Docket Item #6
BAR CASE # 2010-0307

BAR Meeting
November 3, 2010

ISSUE: Revision to Previously Approved Plans
Certificate of Appropriateness for an Addition & Alterations

LOCATION: 1314 King Street

Figure 5. Rear and Side Elevations

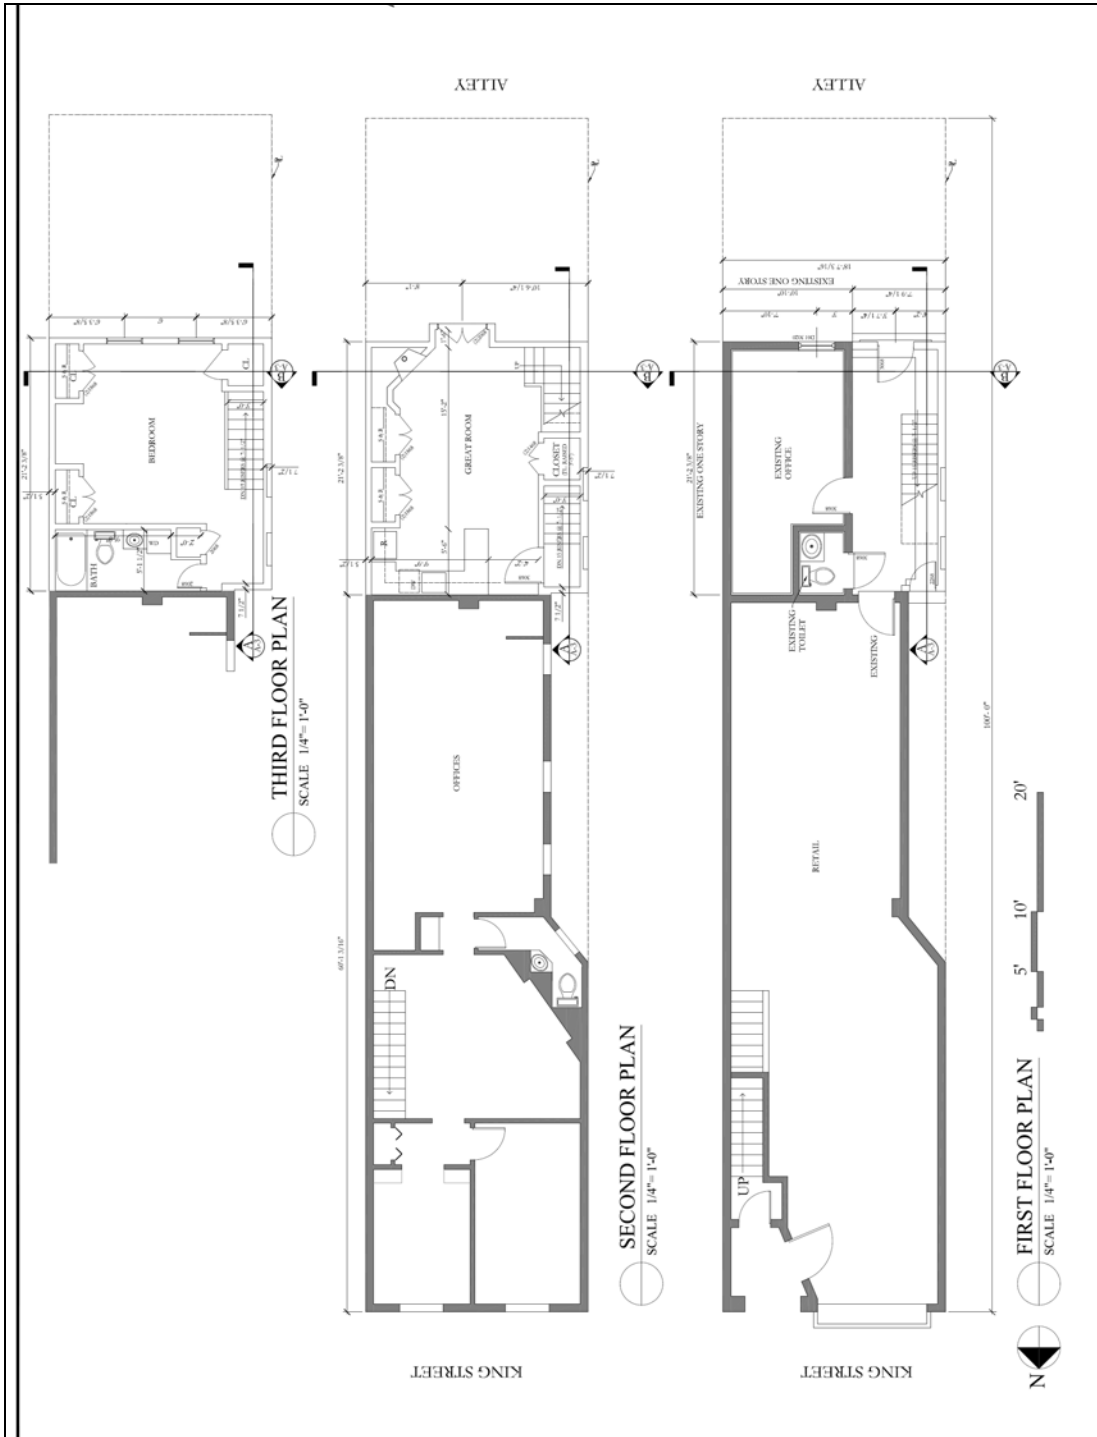
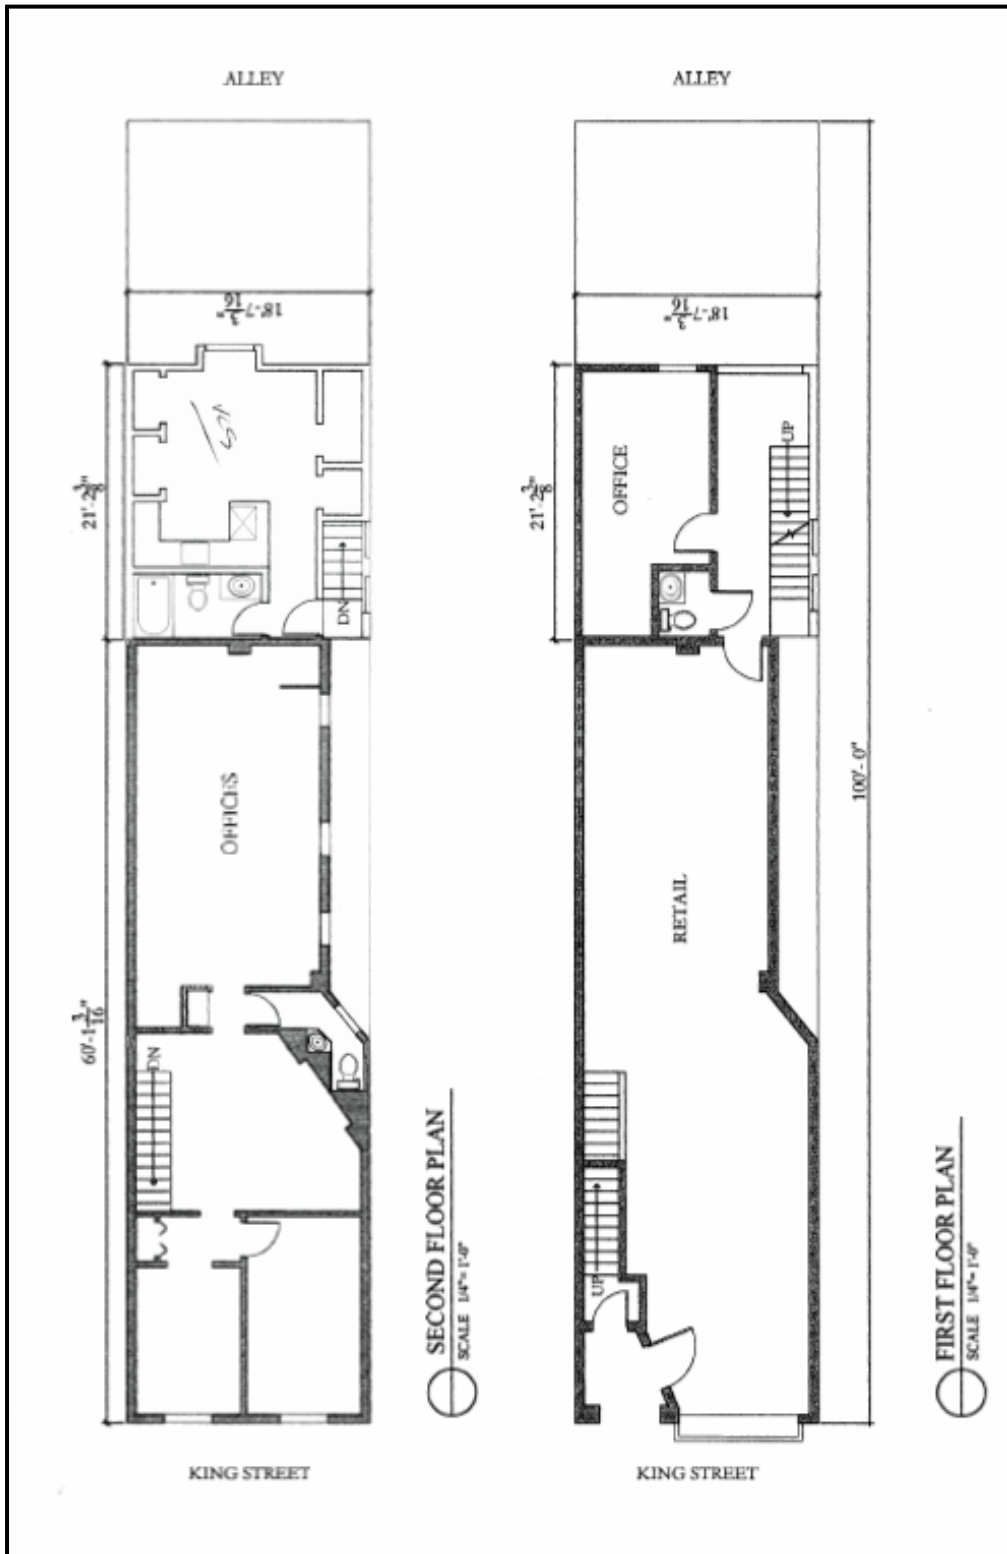
1. That the recessed panels on the west elevation be similar in shape and spacing to the openings on the original building, with Staff review and approval prior to issuance of a building permit.

2. That the new windows are 1/1 to match the windows on the front facade.
3. That the proposed half-glazed wood door is replaced with wood, half-glazed door with two horizontal lower panels.

4. That the balustrade on the Juliet balcony will be fabricated from a black wrought iron. The design and details to be included in the building permit set of drawings.

- Replace the 1/1 window on the second floor of the rear elevation with a set of single, light, painted wood, French doors and a Juliet balcony fabricated with a wood balustrade.

- Replace the pair of solid double doors on the first floor of the rear elevation with a single, half-glazed wood door.

While there is a benefit of breaking up the additions large west elevation with recessed panels, staff continues to prefer their shape and spacing similar to the openings on the historic building. Staff recommends that these minor modifications be reviewed and approved by staff prior to issuance of a building permit.

Finally, the proposed windows are 2/2 simulated divided light, double glazed, painted wood windows and the first floor rear entry door is a simple, half-glazed door. Staff would recommend that more appropriate high-style, Victorian period windows and door be utilized. These would include 1/1 windows (to match the existing windows on the front) and a two-horizontal panel half glazed wood door. These design details are appropriate for an early 20th century storefront.

Figure 4. Floor Plans

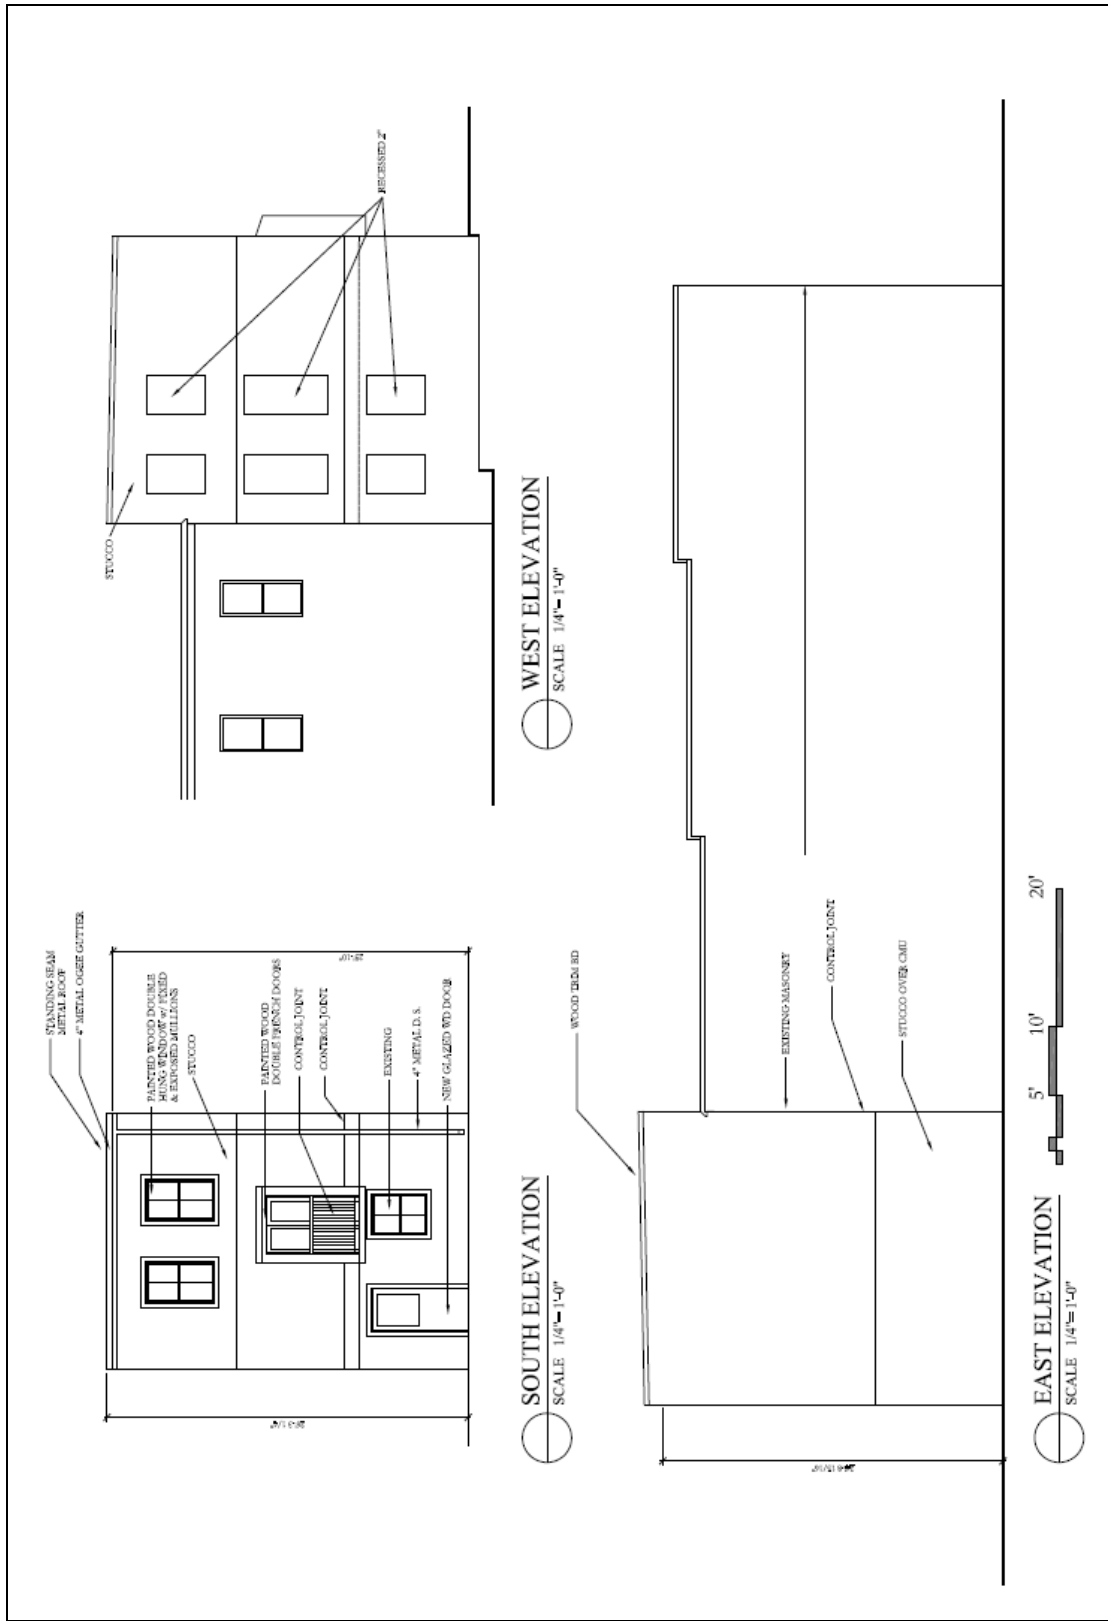
- Increase the overall height of the building from a 2-1/2 story addition to a full three stories. The maximum height of the building will increase from 25' 6-5/16" to 26' 3-1/4".

- Alter the roof shape of the addition from a Flounder roof form which slopes to the east to a low shed roof form, sloping to the south. The roof material will remain standing seam metal painted terra cotta.
